LOWER MANHATTAN COASTAL RESILIENCY PROJECT – BATTERY

Public Design Commission Final Submission Review
August 8, 2022

DESIGN CHANGES

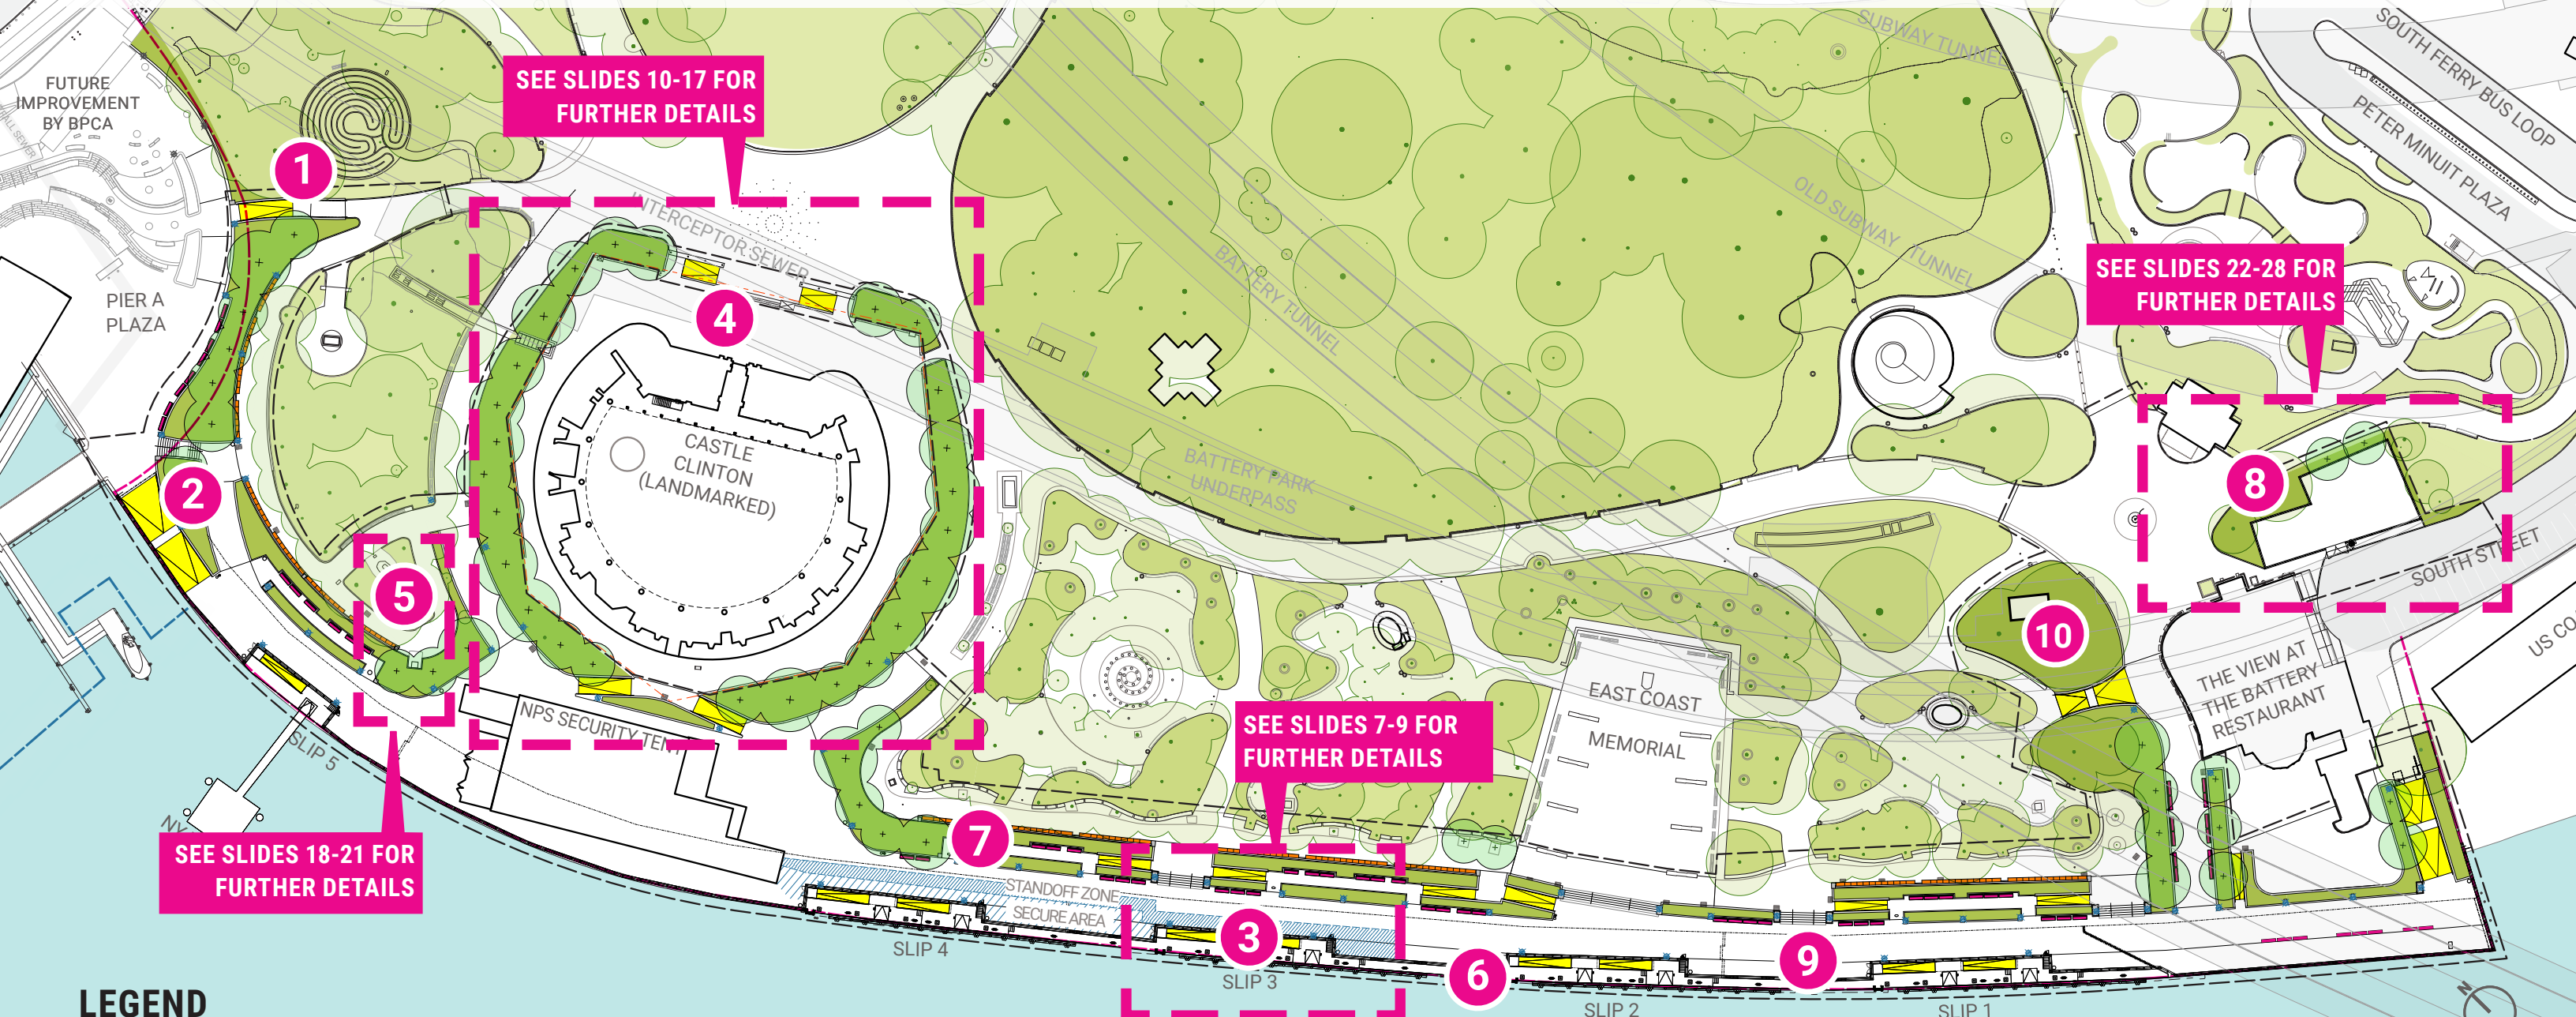
- 1 Pier A ramp connecting to BPCA landing realigned.
- 2 Alignment for the northern ramp between Pier A and the Battery has been refined.
- 3 Two (2) Lightpoles have been added at each slip to provide better lighting.

- 4 Four (4) existing London Plane trees and one (1) existing Crabapple tree within the planted area around Castle Clinton will be removed due to poor health, and new planting are proposed for that area. Ramps added to provide better universal access.

- 5 The Emma Lazarus Memorial relocated towards the southwest per request of Parks to help alleviate damage from skateboards and vehicles.
- 6 River that Flows Two Ways panels shifted to avoid slip piles and expansion joints.

- 7 Armrest design advanced to improve users' experience.
- 8 The M&O area has been developed further to accommodate Parks' needs.
- 9 Paving and furnishing materials finalized. (3) metal plates along promenade serve as expansion joint covers. See page 31 for material palette.

- 10 Extent of planting at East End Tie In revised.

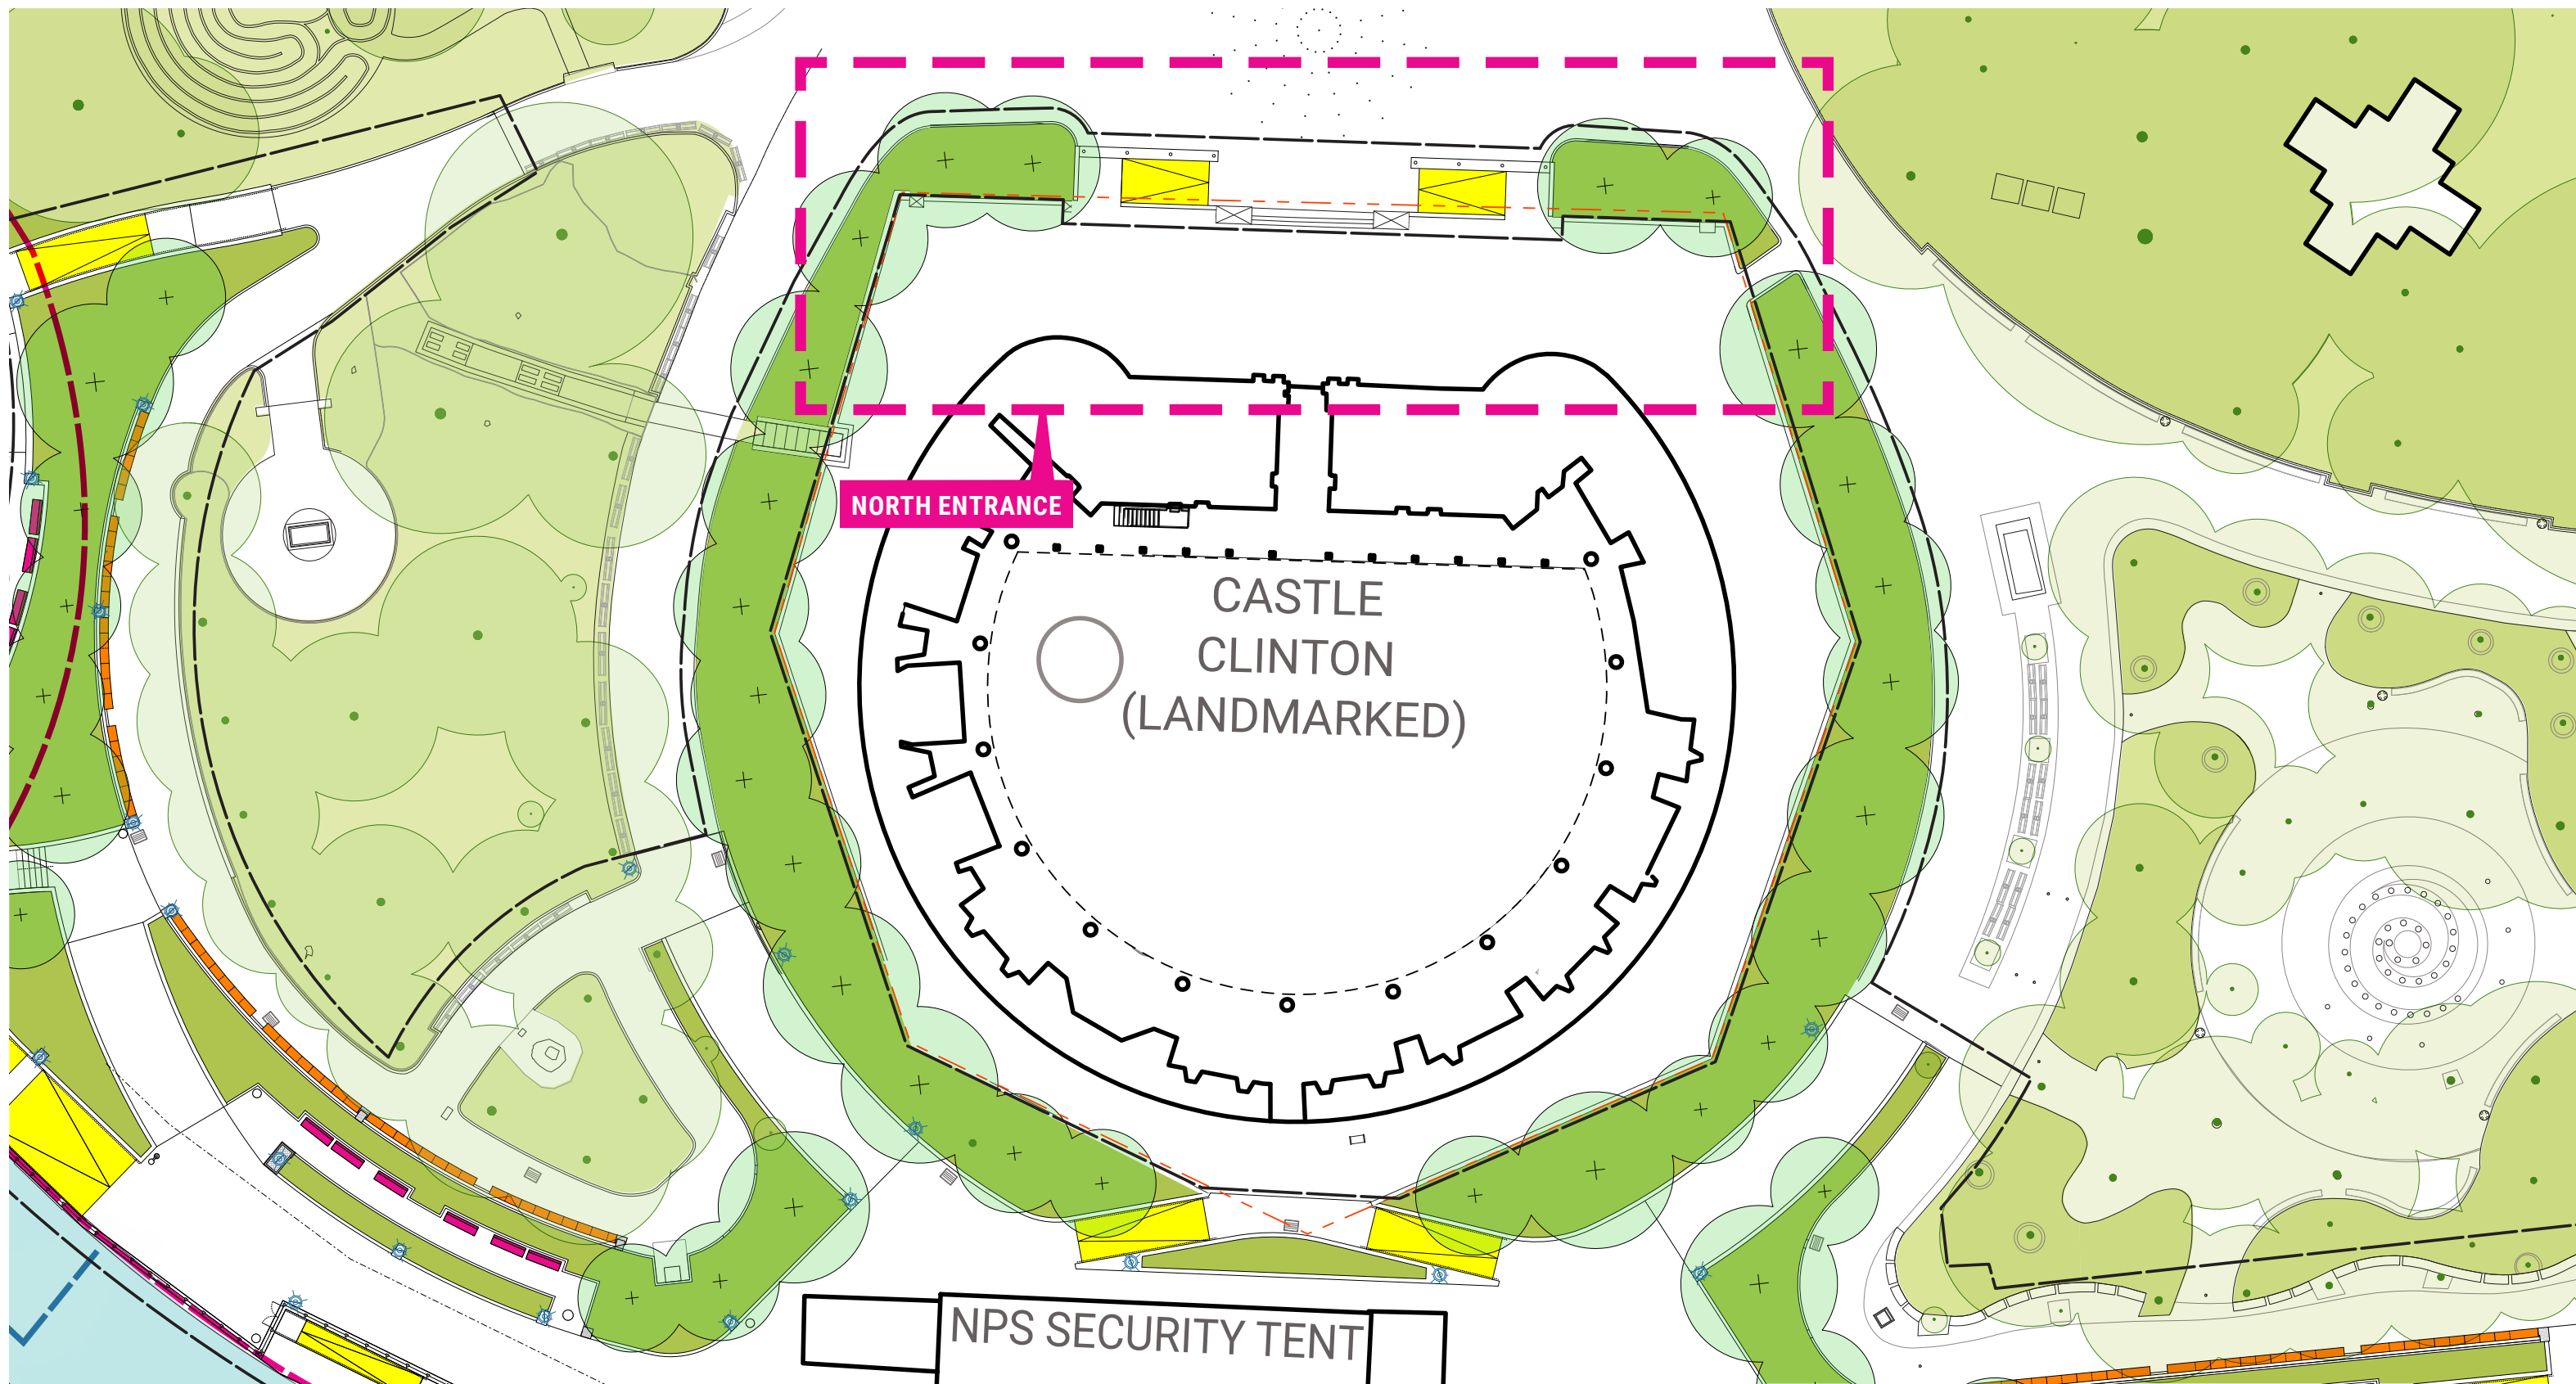
- ADDITIONAL PROPOSED LIGHTING
- BPCA LIGHTING (BY OTHERS)
- PROPOSED LIGHTING (APPROVED IN APRIL 15 AMENDED PRELIMINARY)

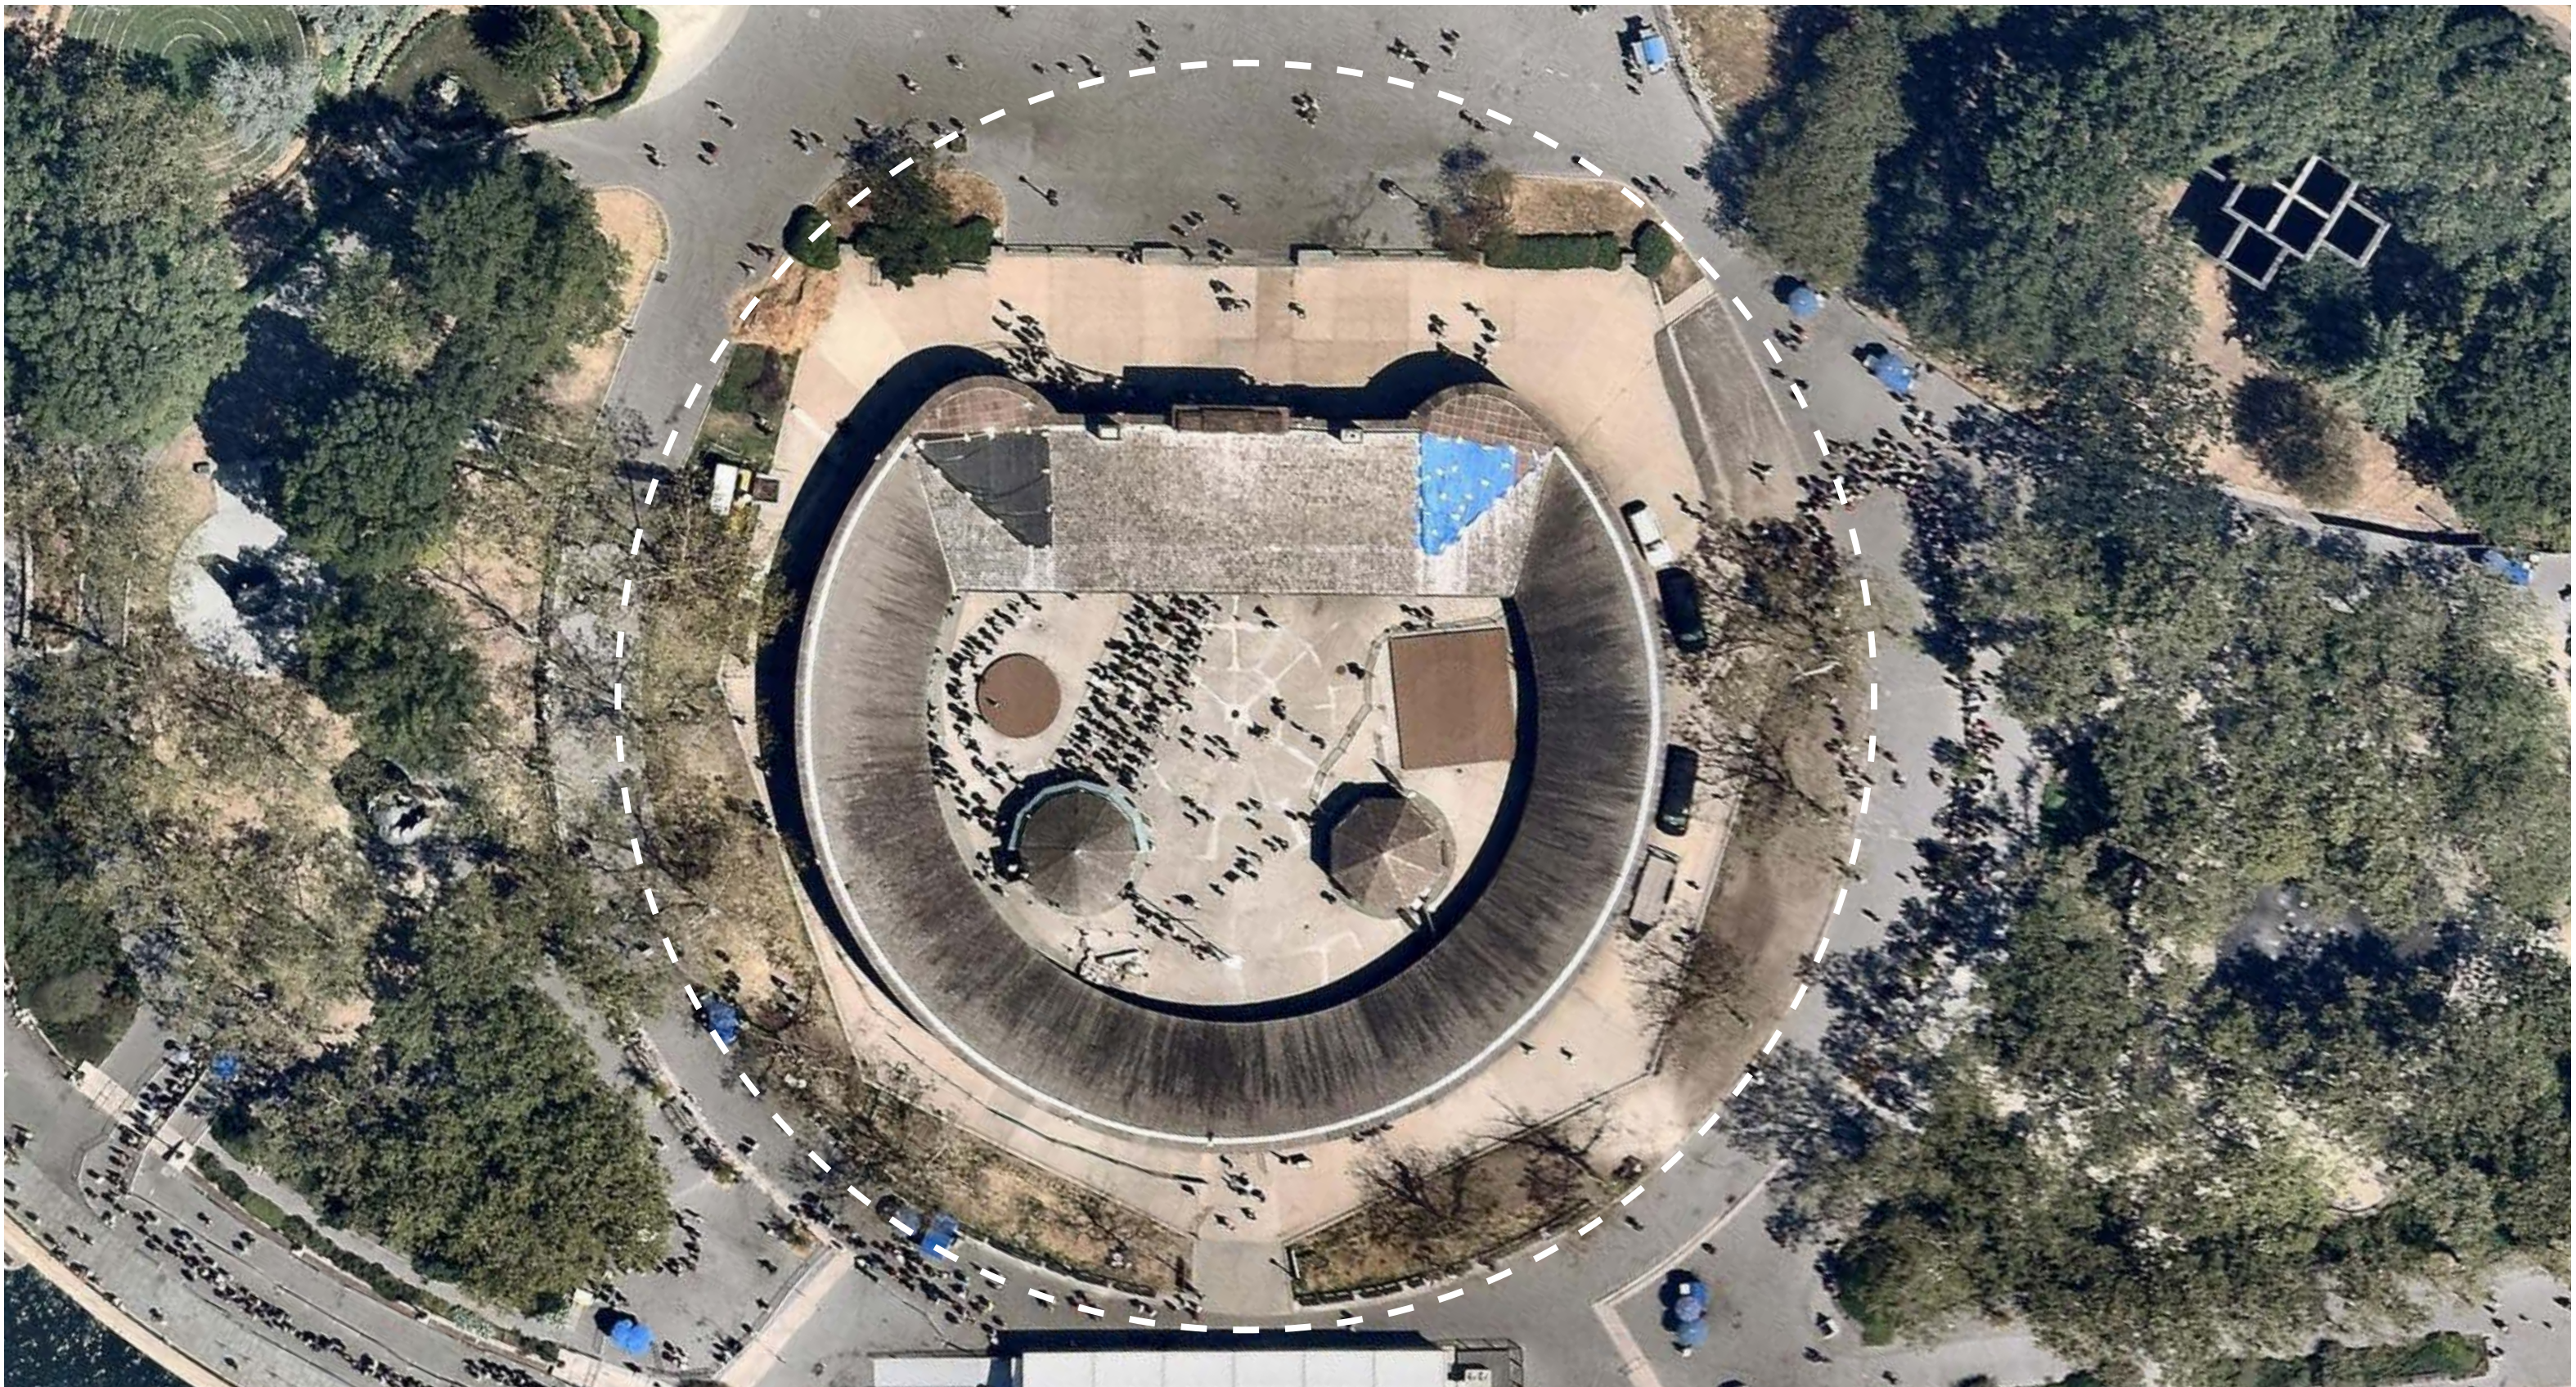
- Without trees there would be a lack of shade in this dashed area
- Four (4) existing London Plane trees and one (1) existing Crabapple tree within the planted area around Castle Clinton will be removed due to poor health, and new plantings are proposed for the entire plant bed around Castle Clinton
